# TECHNICAL SPECIFICATIONS TASK FORCE A JOINT OWNERS GROUP ACTIVITY

TSTF-05-05

SUBJECT: TSTF-449, Revision 4, "Steam Generator Tube Integrity"

TSTF-449, Rev. 4

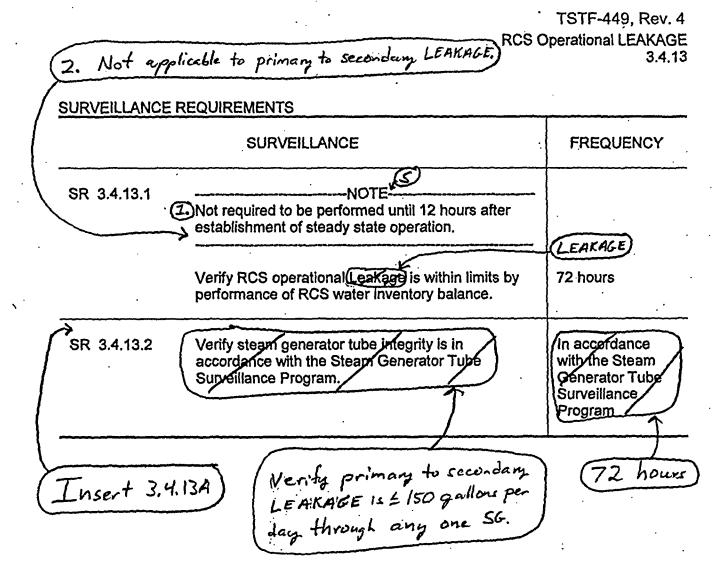
The proposed change revises TS 3.4.13, "RCS Operational LEAKAGE," by reducing the allowable leakage from any one steam generator (SG) to 150 gallons per day. The proposed change also deletes the existing LCO 3.4.13.d since it is enveloped by the revised LCO and revises the Conditions and Surveillances to clarify the requirements related to primary to secondary LEAKAGE.

If primary to secondary LEAKAGE exceeds 150 gallons per day through any one SG, a plant shutdown must be commenced. MODE 3 must be achieved in 6 hours and MODE 5 in 36 hours. The existing technical specifications allow 4 hours to reduce primary to secondary LEAKAGE to less than the limit. The proposed technical specification removes this allowance.

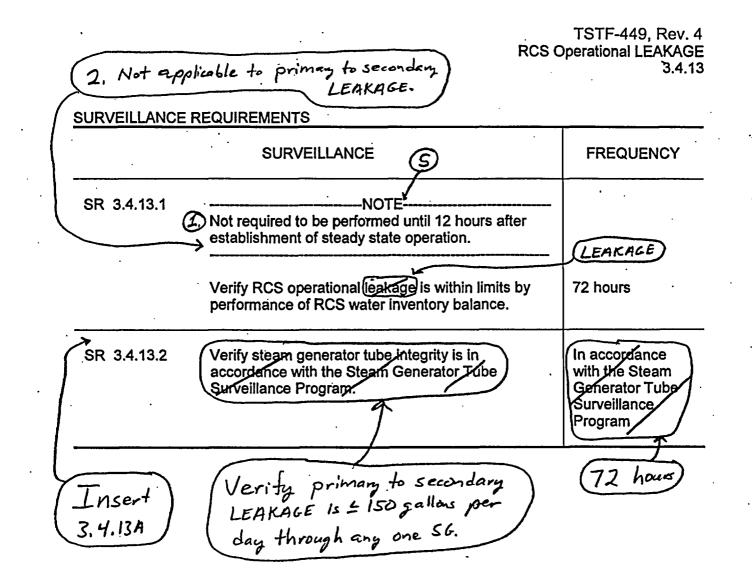
$\int$		Operational	l, 2, 3, ar	d 4.	
		CONDITION		REQUIRED ACTION	COMPLETION TIME
	A.	RCS LEAKAGE not within limits for reasons other than pressure boundary LEAKAGE	A.1	Reduce LEAKAGE to within limits. man to secondary AKAGE	4 hours
0	В.	Required Action and associated Completion Time of Condition A not met. <u>OR</u> Pressure boundary LEAKAGE exists.	B.1 <u>AND</u> B.2	Be in MODE 3. Be in MODE 5.	6 hours 36 hours
		OR Primary to secondary EAKAGE not within imit. GSTS	$\overline{)}$	3.4.13-1	Rev. 3.0, 03/31/04

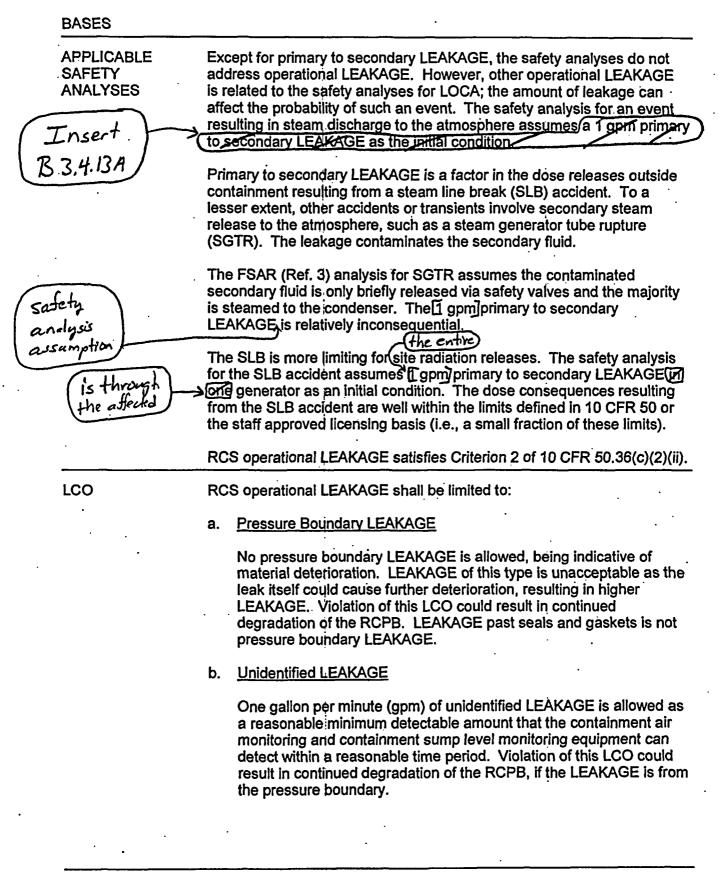
An OPERABLE RCS loop consists of at least one OPERABLE RCP and an SG that is OPERABLE (in accordance with the Steam Generator Tube) Surveillance Program and has the minimum water level specified in SR 3.4.6.2.
